**WINCHESTER COMMONS
CONDOMINIUMS**

WINCHESTER,
CONNECTICUT

Environmental Review Team Report

APRIL 1989

Figure 2

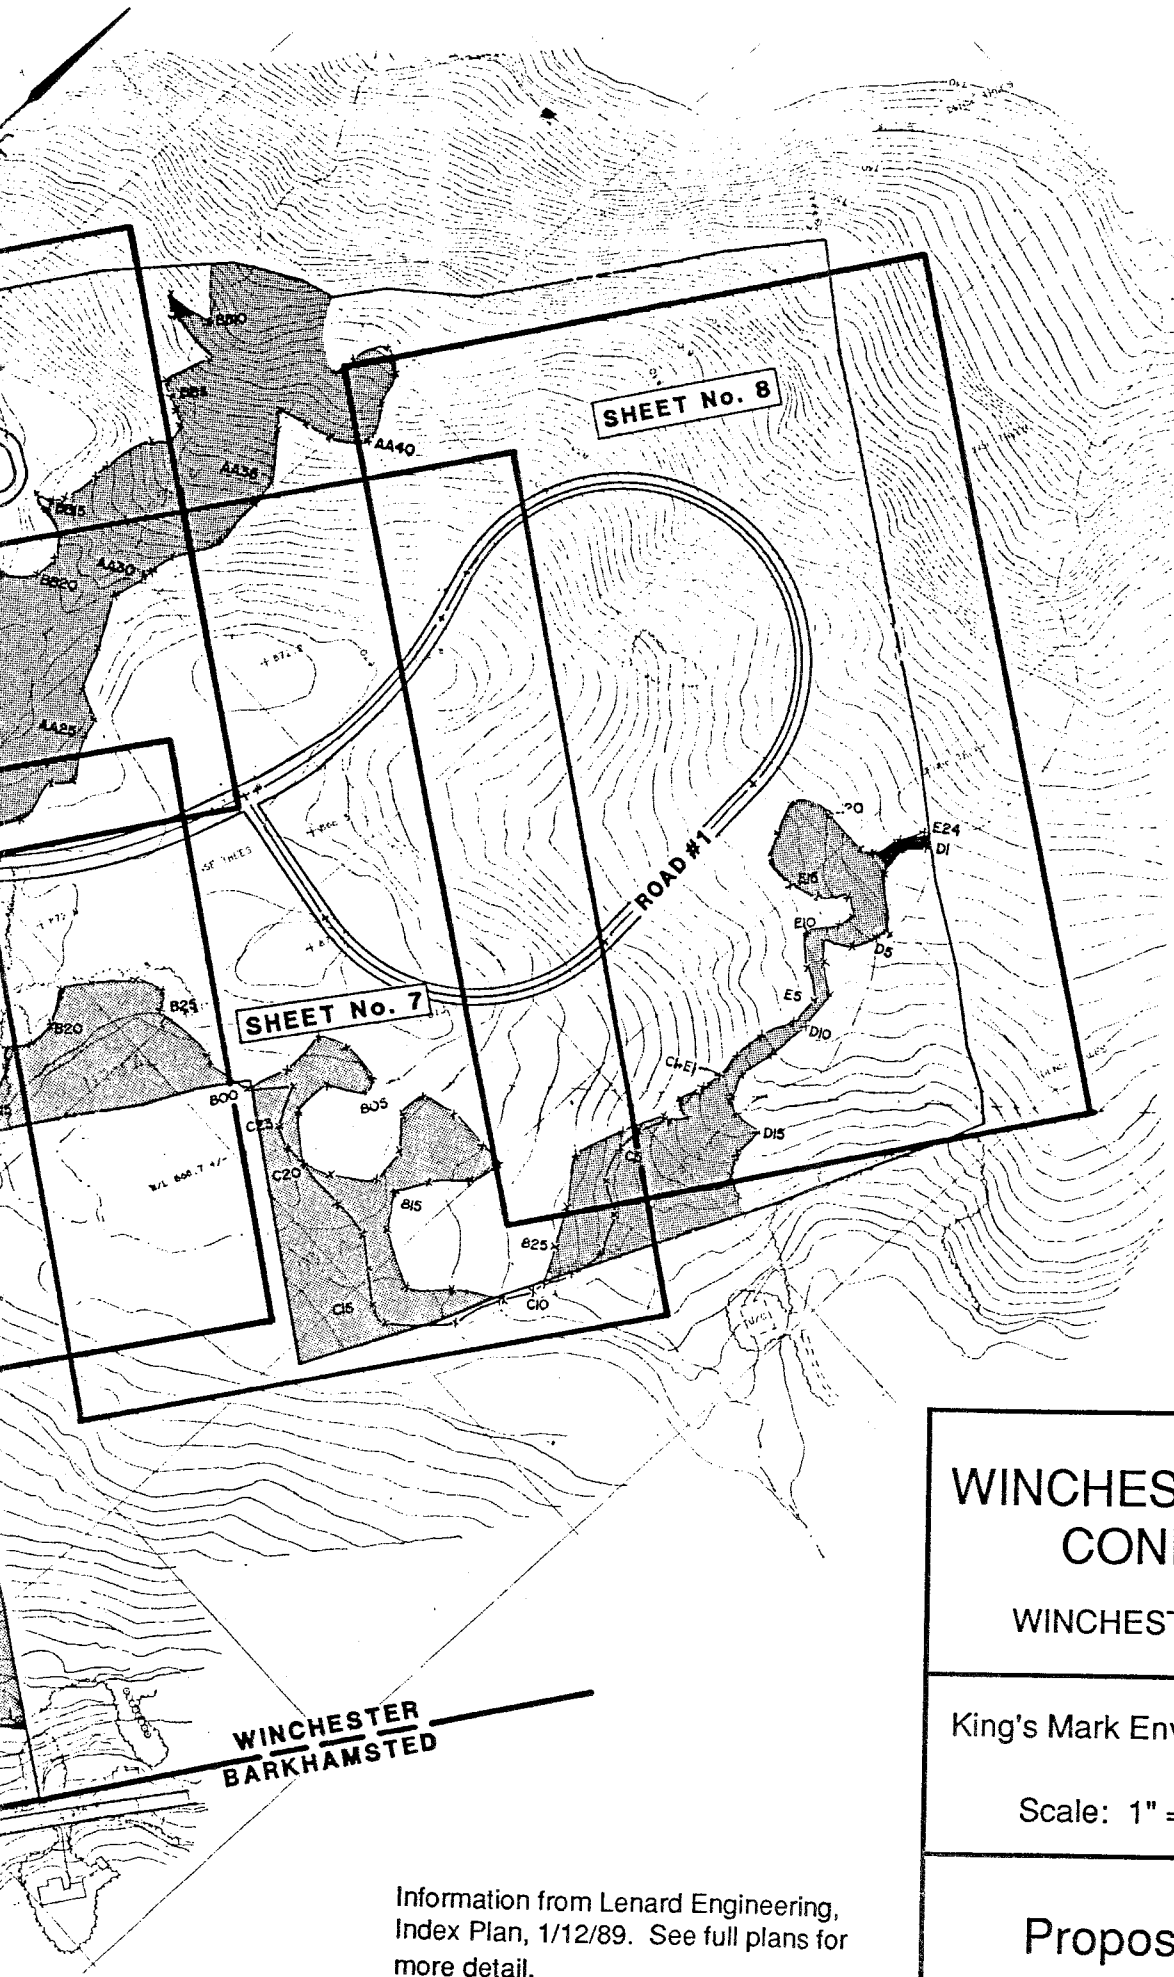
A review of existing plans indicates that alternatives to the present road layout exist which would reduce wetland disturbances. The major wetland road crossing (B-7) could be shifted about 840 feet to the west, thereby eliminating the wetland crossing altogether. Other alternatives appear to exist and should be carefully considered by the applicant and his technical staff. Also, every effort should be made to keep building units set back from wetlands. In some places, building units are proposed on immediate wetland margins. Setbacks will reduce the chance for illegal filling and provide more usable yard space for residents (see Wetland Considerations section).

The project contains 4 different roadway crossings of wetland areas and proposes to place 2 large detention areas within existing wetlands. The first and largest crossing (B-7) is located at the southern access point to the site, off of Wallens Hill Road. This crossing will traverse approximately 600 feet of a forested and shrubby swamp area. The roadway construction would consist of some excavation and filling where needed and create an 80-100-foot wide corridor of disturbance. The applicant also proposes to construct an arch culvert over an area which conveys water from a pond located on an adjacent property. The overall impact from this crossing would be the loss of 0.75 acres of high quality wetland area and create a continual flow of road water runoff and sediments directly into the wetlands (see pages 6 & 8 of the applicant's Natural Resources Inventory and Wetland Impact Assessment). Additionally, the bisection of this system would create a barrier to wildlife migration through the area and inhibit the natural flow and drainage patterns which presently exist. This crossing may be unnecessary due to the existence of an alternative location for access to the site within the same area (see alternative #2 within Engineering and Environmental Reports on Wetlands Disturbances). This alternative, which would not require any wetland impacts, should be fully explored by the applicant and used if at all possible. Lastly, the application gives little to no justification for the design route chosen considering the severity of resulting wetland impacts.

- 1) With respect to the first wetland crossing, it is recommended that the alternative right-of-way located further south on Wallens Hill Road be used if at all possible. The proposed crossing represents a significant wetland impact and creates the potential for continual secondary impacts due to road maintenance and traffic volumes.

- 2) The third wetland crossing (in the area of the sugar maple grove) is also of major concern. All attempts should be made to remove the proposed roadway from this area and use alternative road designs to access buildable areas.

- 3) Construction of detention and/or retention facilities within existing wetland areas should be discouraged, and efforts should be made to place them within suitable upland areas if at all possible. The facility proposed within the central portion of the site (Wetland A) may be acceptable because impacts will be minor. However, the detention facility proposed within the forested and organic swamp area along the western border of the site (Wetland D) should be discouraged, and all possible alternatives to eliminating this basin should be explored, including the reduction of the development density to minimize increases in runoff from the site.

Figure 5

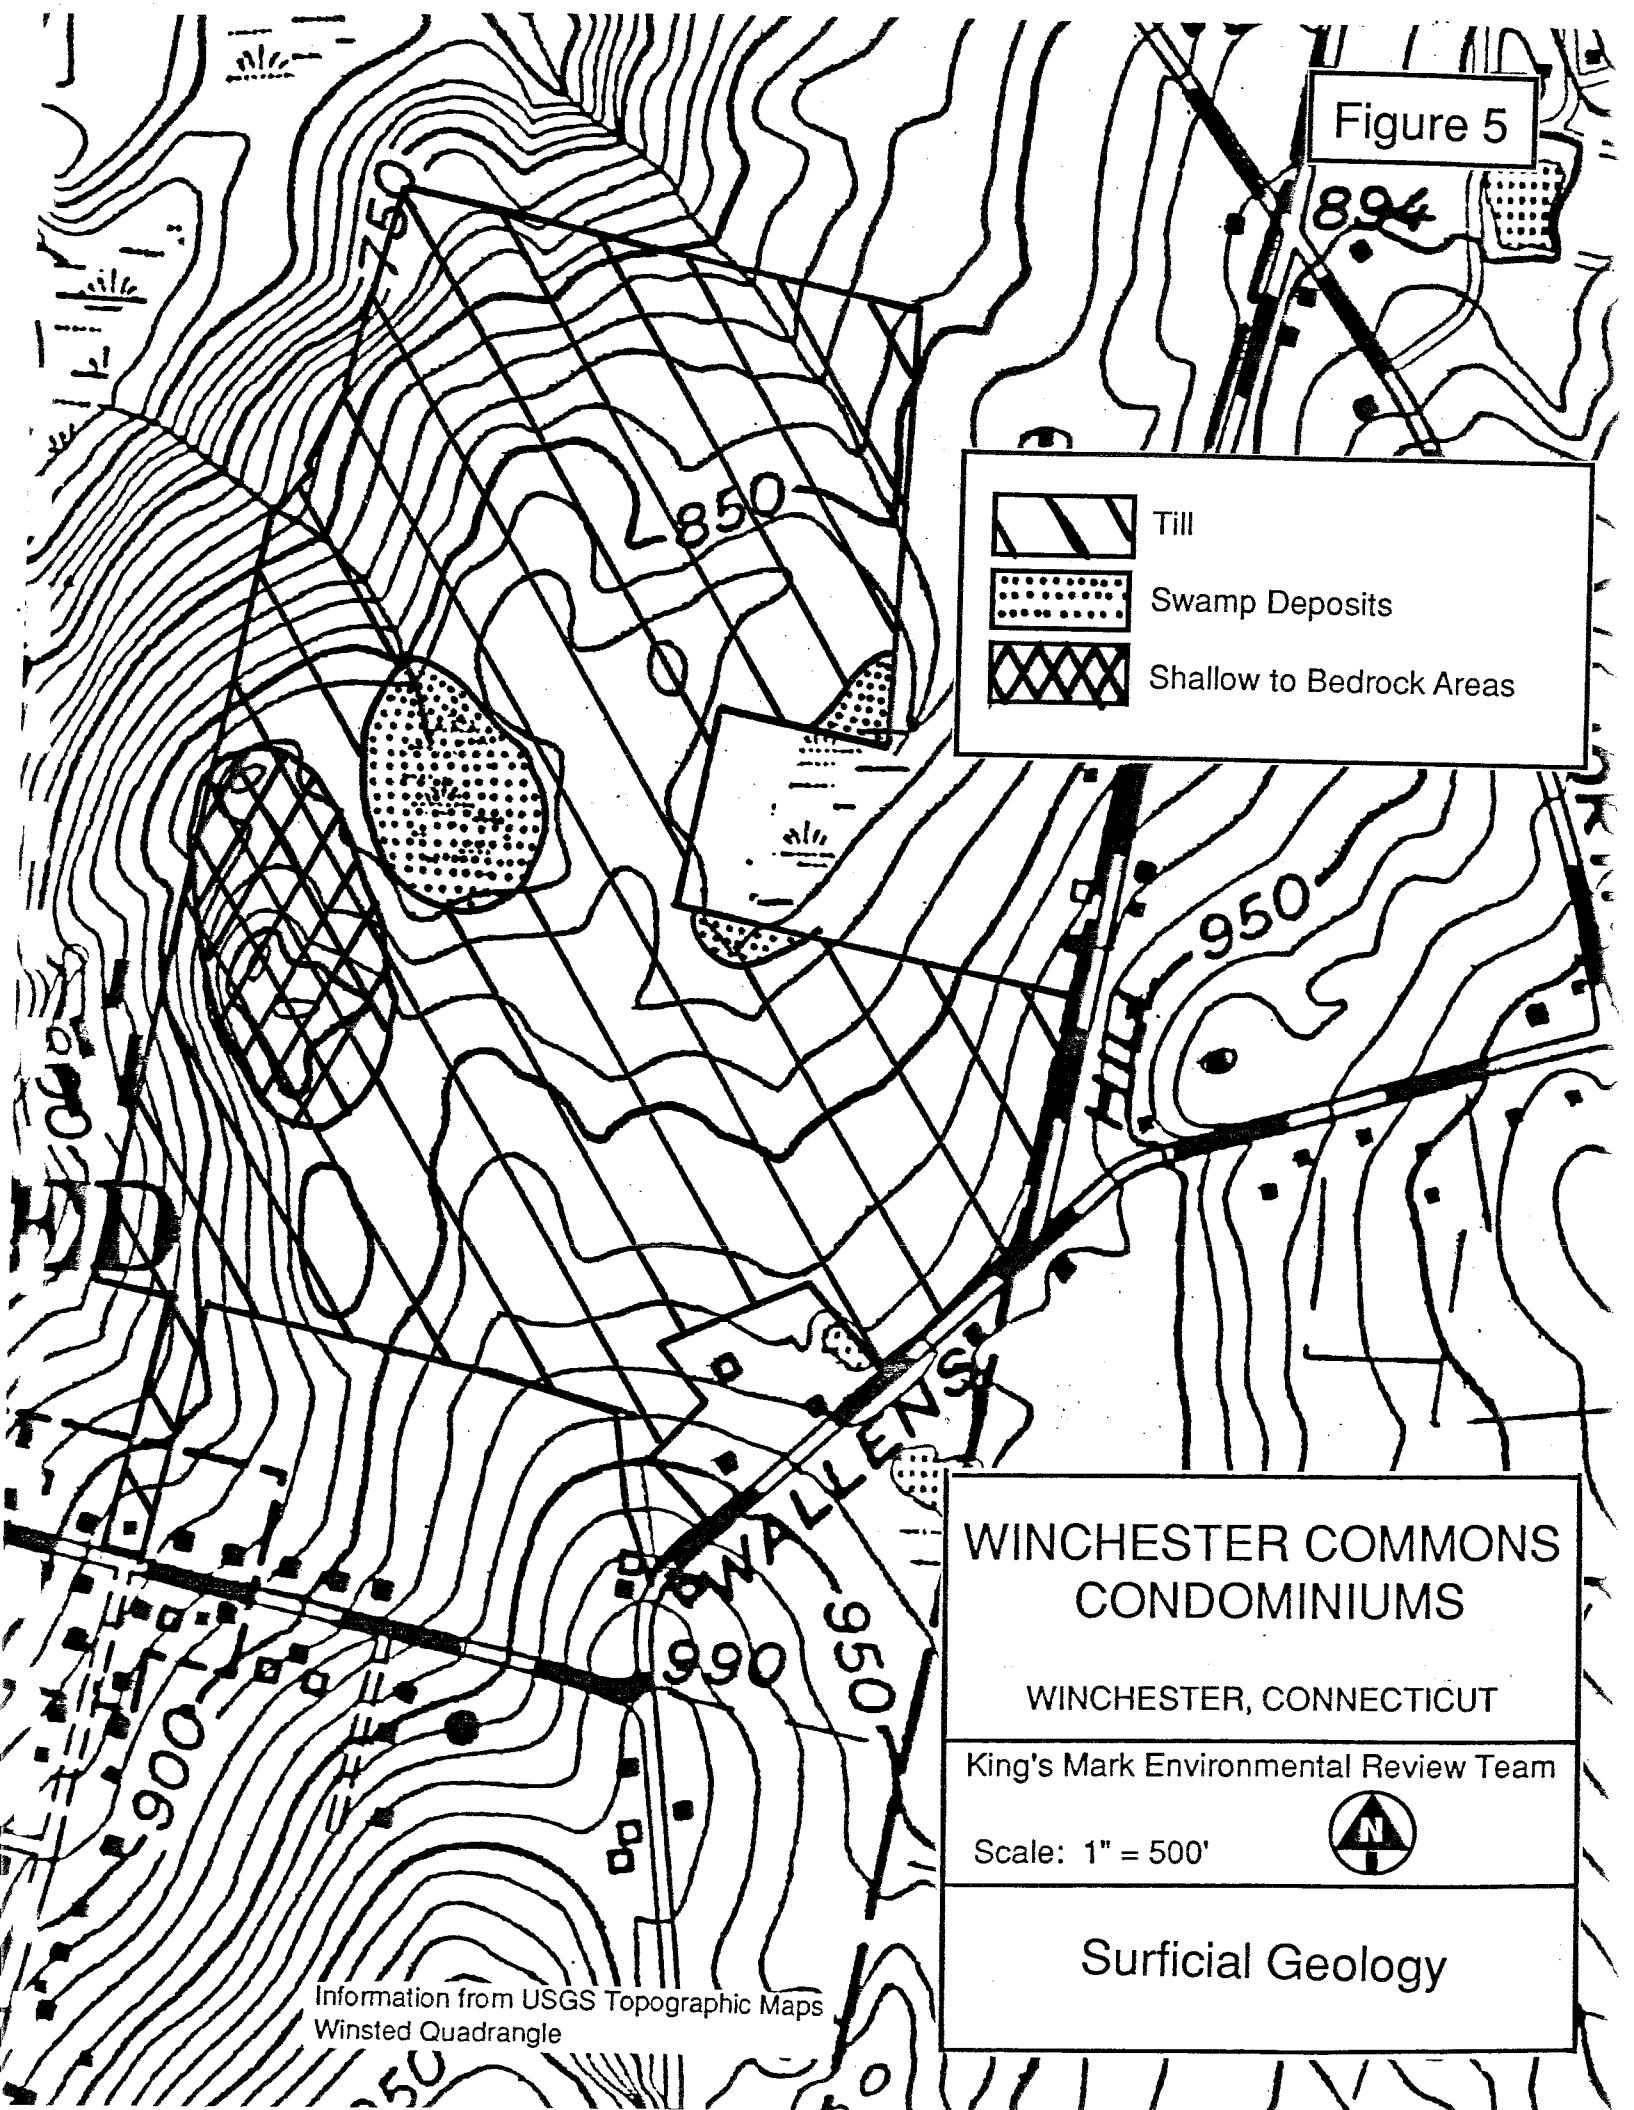
As noted by the Soil Survey for Litchfield County, the texture of the till on-site ranges from sandy, stony and loose to silty and compact. In general, the compact variety (hardpan) is found mostly in the open fields. The remainder of the site is covered by till which is sandier and less compact.

The thickness of the till on the site is variable. It is probably shallowest on the knob southwest of Wetland D in the central parts. Well records at 2 locations near the site (Wallens Hill Road) indicate the till is 20 feet thick.

(2) an area of shallow to bedrock soils southwest of the Wetland D on the site, (3) the presence of regulated wetland soils, and (4) the presence of steep slopes at the western limits.

The shallowest soil cover is located in the western parts of the site. Blasting may be needed for utility lines, foundations, roads, etc., where solid bedrock is encountered. Any blasting that takes place on the site should be done only under the strict supervision of persons familiar with the latest blasting techniques. Only then will the effects of blasting be kept to a minimum. Also, completion of all blasting prior to construction should be considered.

Figure 6

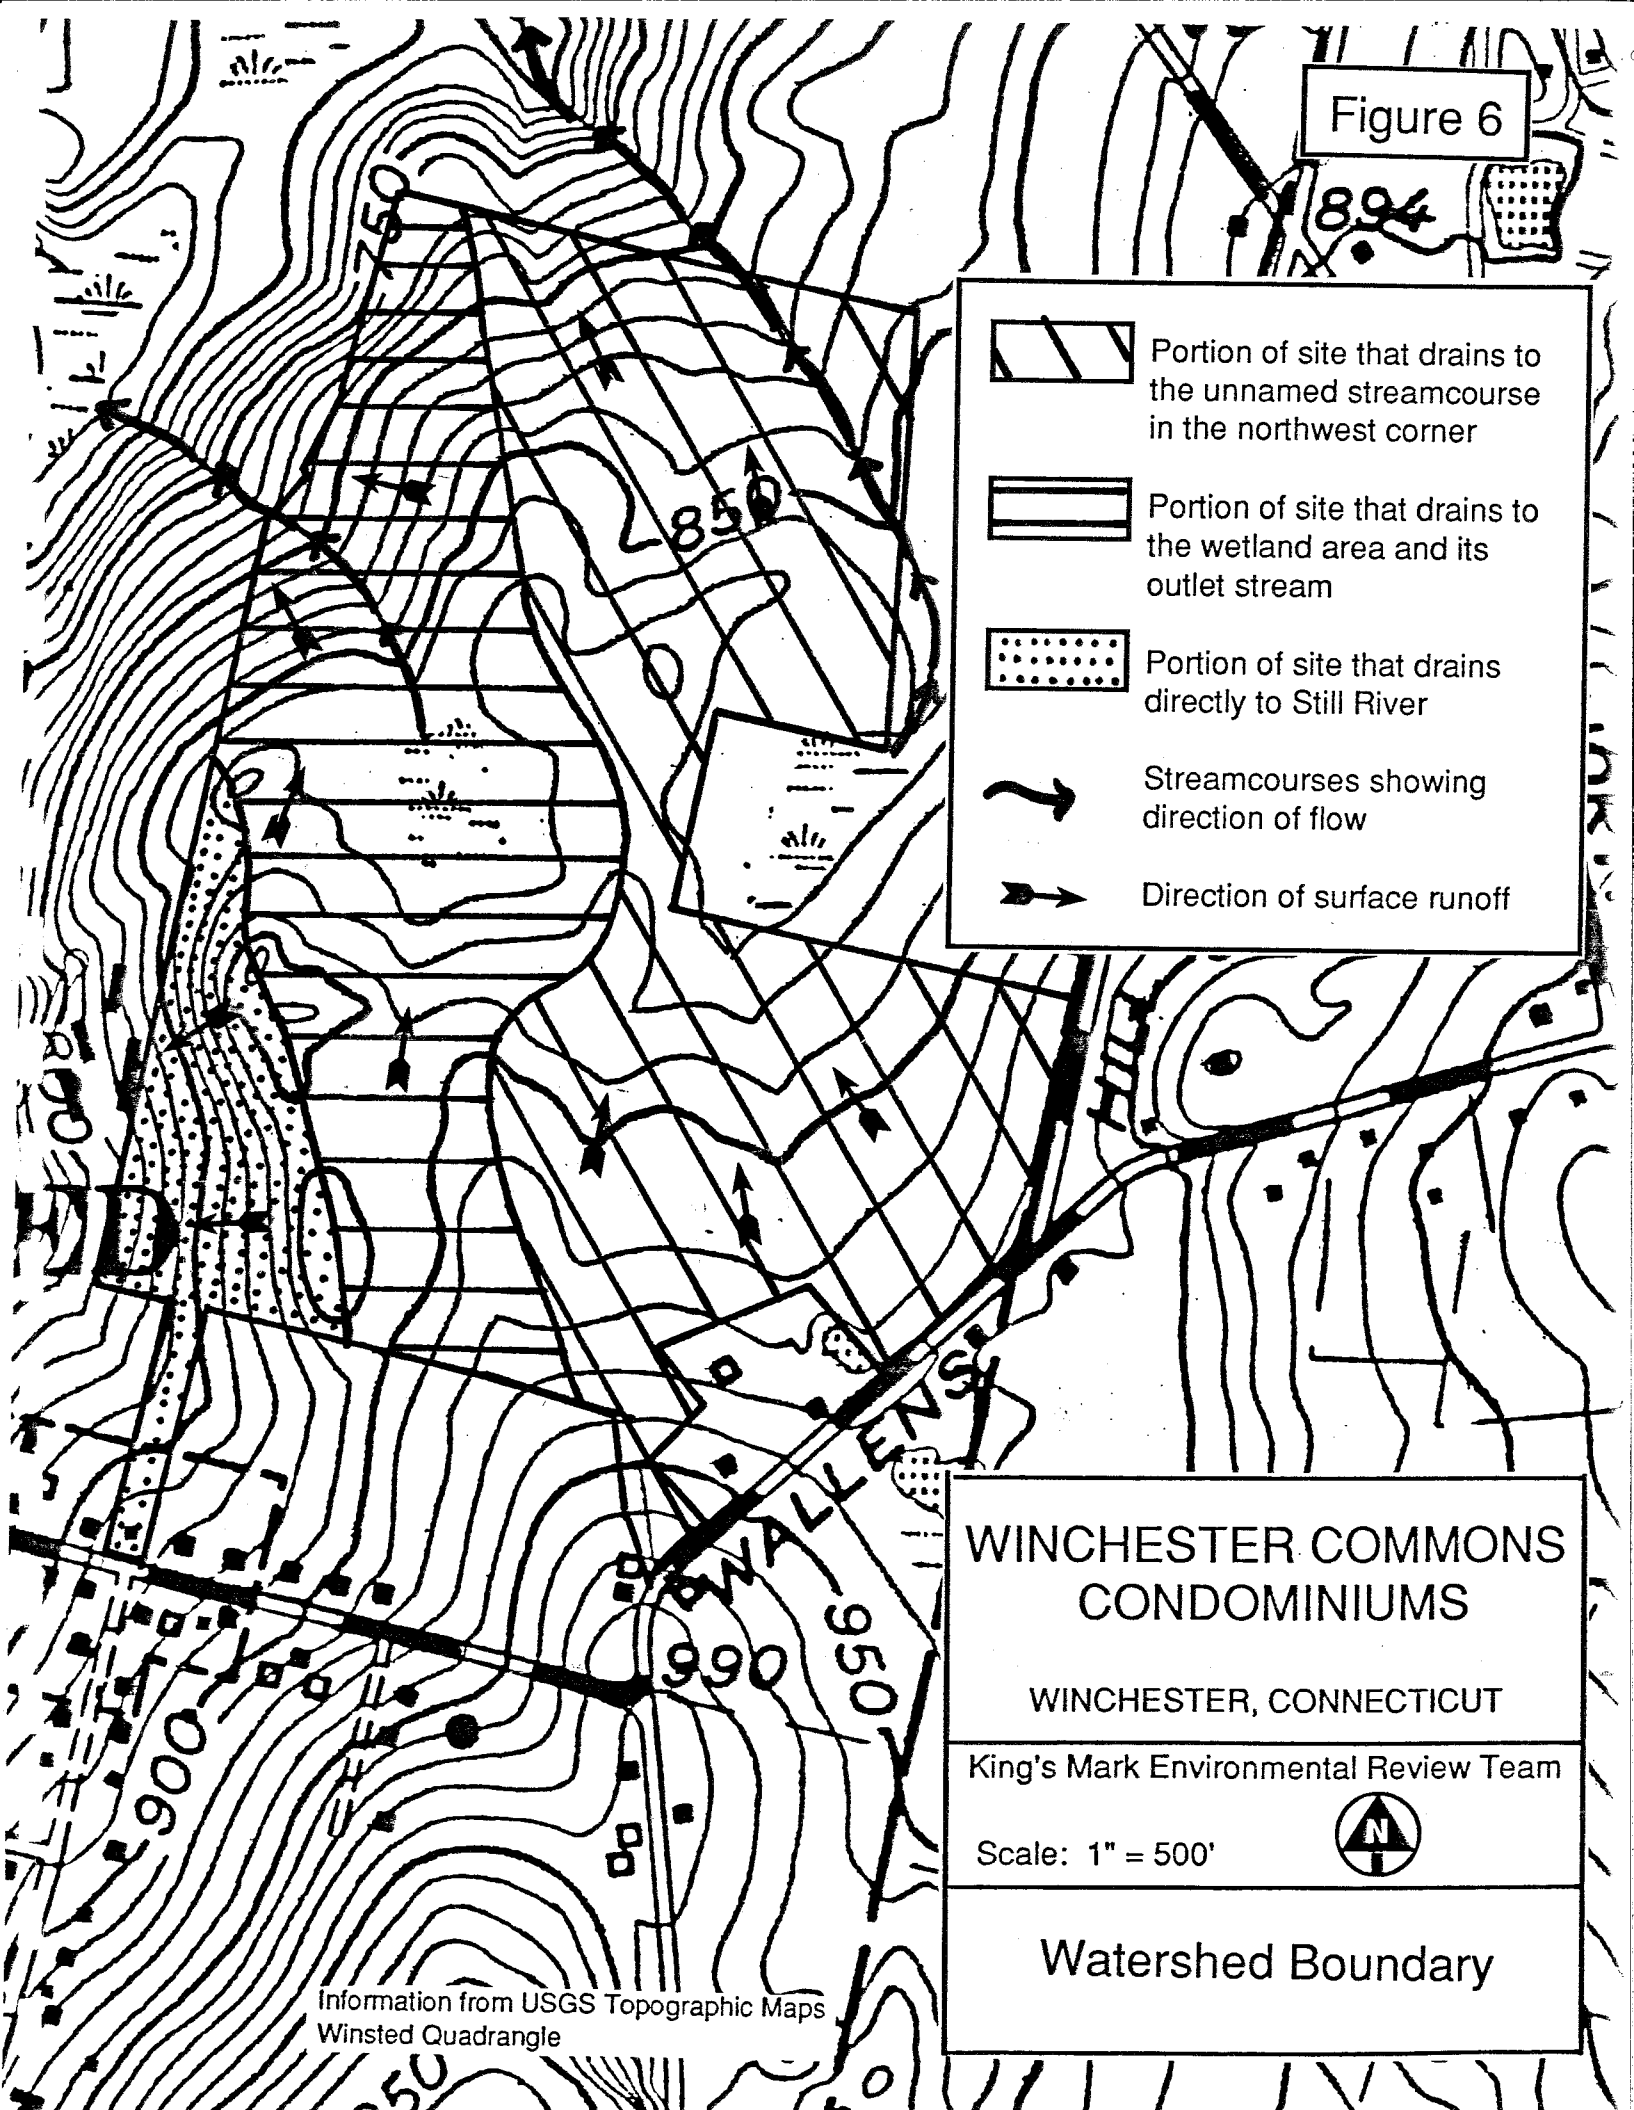
The site, which lies entirely within the Still River drainage basin, can be divided roughly into 3 sub-drainage areas (see Figure 6). Surface runoff arising in the central and eastern parts drains to the unnamed streamcourse which flows through the northeast corner of the site. It flows into a wetland area just above Still River. Surface runoff that arises in the western parts flows to the wetland located in the westcentral parts or to its outlet stream. The water then flows to a wetland pocket which is also located just above Still River. Finally, surface runoff in the southern parts drains westward to a topographic swale which routes the water to Still River.

The condominium development as planned, followed by the construction of buildings, roads and parking areas, is expected to lead to increases in the amount of runoff shed from the site. According to the drainage facilities report supplied by the applicant's technical staff, post-development runoff conditions will not exceed pre-

particles (clay and silt), dissolved contaminants (salts, etc.) and fluid contaminants (spilled hydrocarbons, fuels, etc.) will not be effectively retained by most structures.
